SUNDRY NOTICES AND REPORTS ON WELLS (DO NOT USE THIS FORM FOR PROPOSALS TO DRILL OR TO DEEPEN OR PLUG BACK TO A DIFFERENT RESERVOIR. USE "APPLICATION FOR PERMIT" (FORM C-101) FOR SUCH PROPOSALS.)		WELL API NO. 30-041-20399

A-Plus P&A LLC plans to P&A this well per the attached procedure.

Plug and Abandonment Procedure

Chaveroo San Andres Unit #7

State of New Mexico		PROPOSED	
Author:	Abby @ JMR	Well No.	#7
Well Name	Chaveroo SA Unit	API #:	30-041-20399
Field/Pool	Chavaroo; SA	Location:	M-35-07S-32E
County	Roosevelt	State	NM
Spud Date	3/17/1975	GL:	4475'

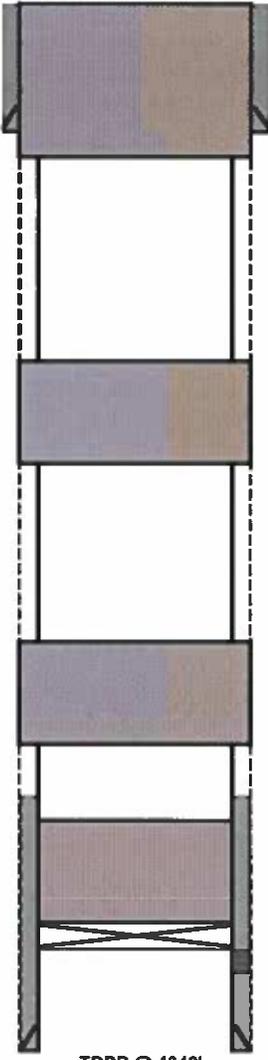
Plug #3: Yates, B/Salt, Rustler formations: Mix and pump 140 sxs Class C cement from 2305' to 1750'. WOC & Tag @ 1750' or above.

104
 outside = 1405x
 inside = 585x

Plug #2: Queen formation: Mix and pump 60 sxs Class C cement inside/outside from 2970' to 2770'. WOC & Tag @ 2770' or above.

43
 outside = 275x
 inside = 165x

Plug 1: San Andres perforation and top: Set 5 1/2" CIBP @ 4157'. Spot 80 sxs Class C cement @ 4157 to 3435'. WOC & Tag @ 3435' or above.

75
